Technical Preservation Services
Preservation Assistance Division
National Park Service
U.S. Department of the Interior
Washington, D.C.

Interpreting the Secretary of the Interior's Standards for Rehabilitation

Volume III

9. Drawing of proposed window and original window and frame location. Note how new sash and frame are set closer to the exterior and within the window opening. The owner's alternative panning identified above will not correct the deficiencies of the sash.

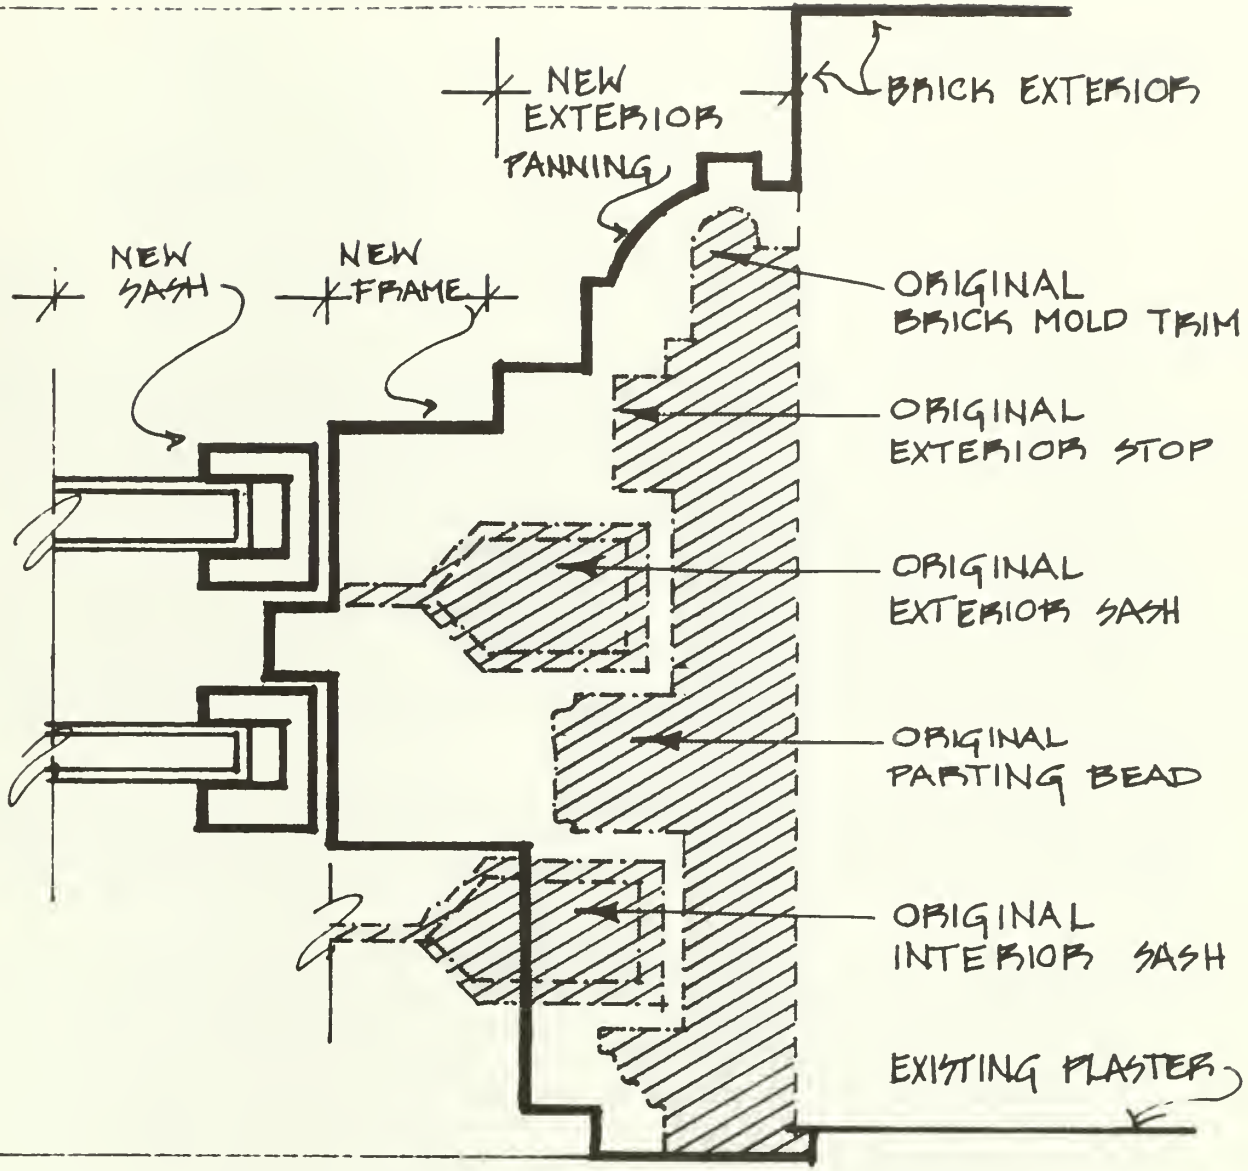
8. Proposed replacement windows on third floor and original windows below. Note how dark sash and frames are unobtrusive, light sash and frames create a striking pattern on the red brick facade.
